(12) Remote Shutdown System (Section 7.1.4.4, 7.4.2.3, SER and Section 7.4.2.3, SSER-3 and SSER-5)

In the Matter of : Docket No.: 50-352
PHILADELPHIA ELECTRIC COMPANY :
(Limerick Generating Station, :
Unit No. 1)

I hereby certify that copies of the foregoing Application for Amendment of Facility Operating License NPF-39 in the above captioned matter were served on the following by deposit in the United States Mail, first-class postage prepaid, on the 11th day of May , 1988.

REACTOR ENCLOSURE
 COOLING WATER
 CONTAINMENT ISOLATION PROVISIONS

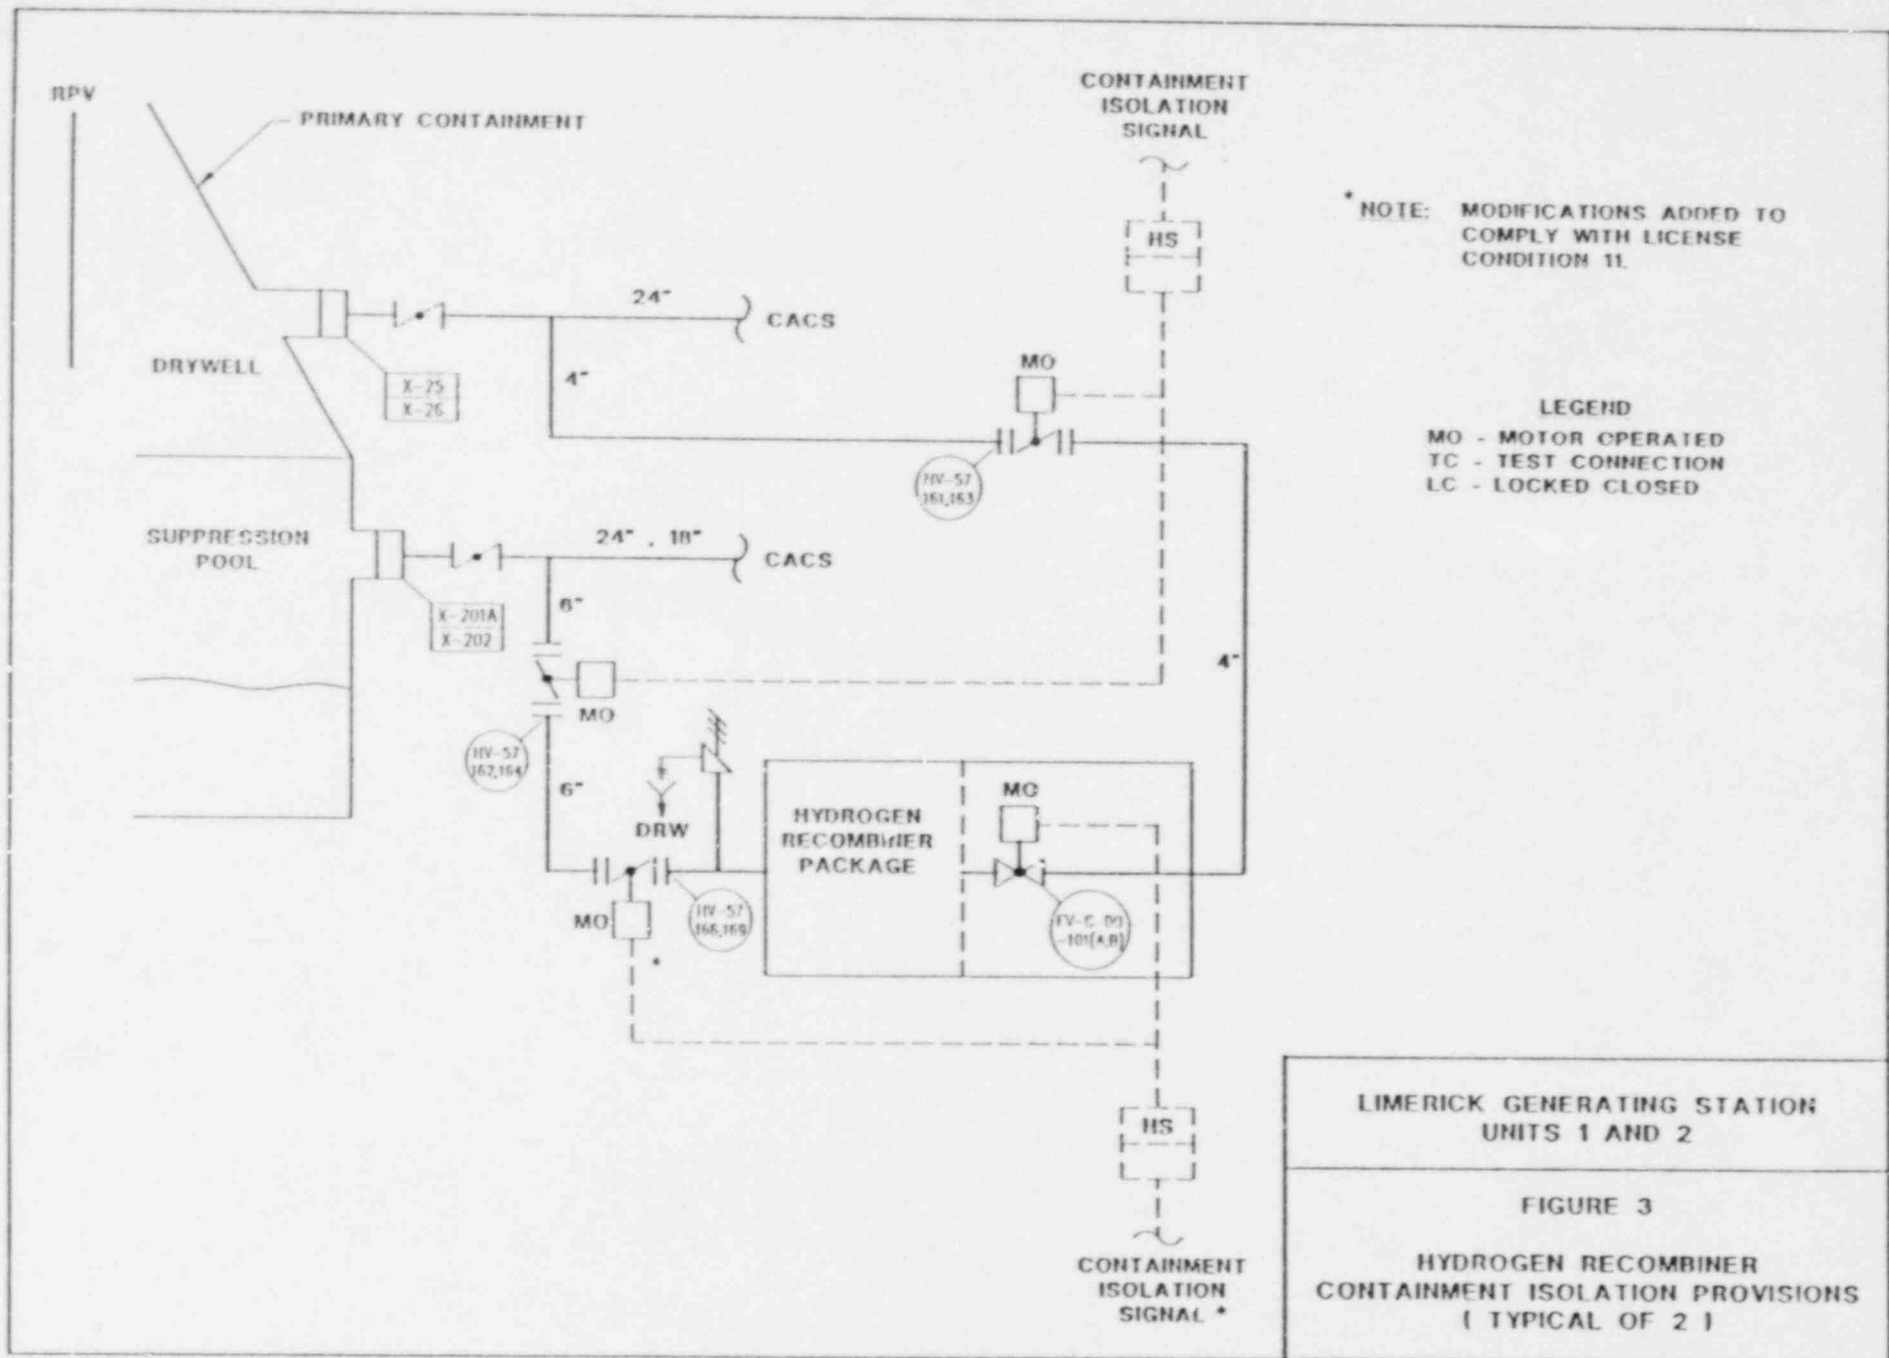
* NOTE: MODIFICATIONS ADDED TO COMPLY WITH LICENSE CONDITION 11.
